SERVICE ADVISORY

NO.: 1514 Rev B

SUBJECT: Potential Erroneous Lateral Guidance

Figure 1 – Erroneous Anticipated Turn (Circular Leg)

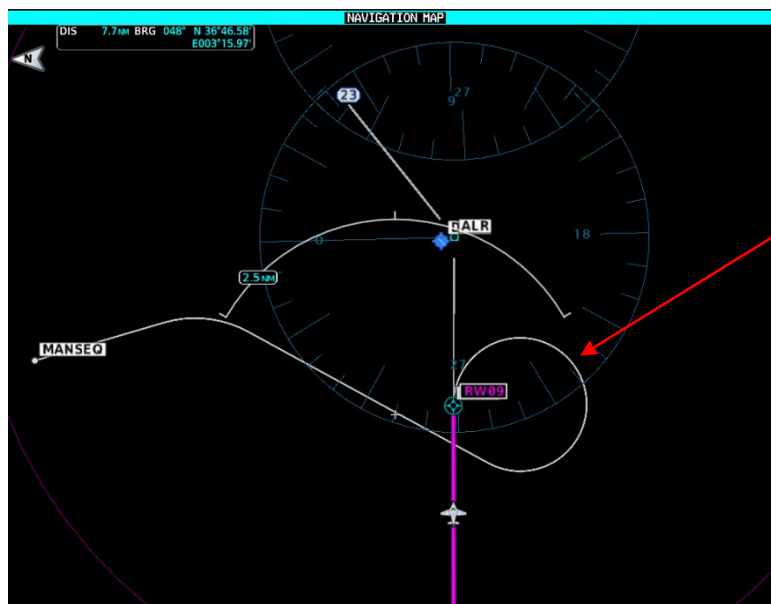
The condition appears in the form of a circular leg drawn on the Navigation Map page to indicate a turn in the opposite direction and is added at the intersection of two procedure legs that are not associated with a FAF (see Figure 1).

Monitor the Navigation Map page on the MFD when flying terminal procedures and always compare displayed flight path depictions with applicable published procedures. If this condition occurs, follow CDI course guidance manually and/or by using AFCS Heading Mode.
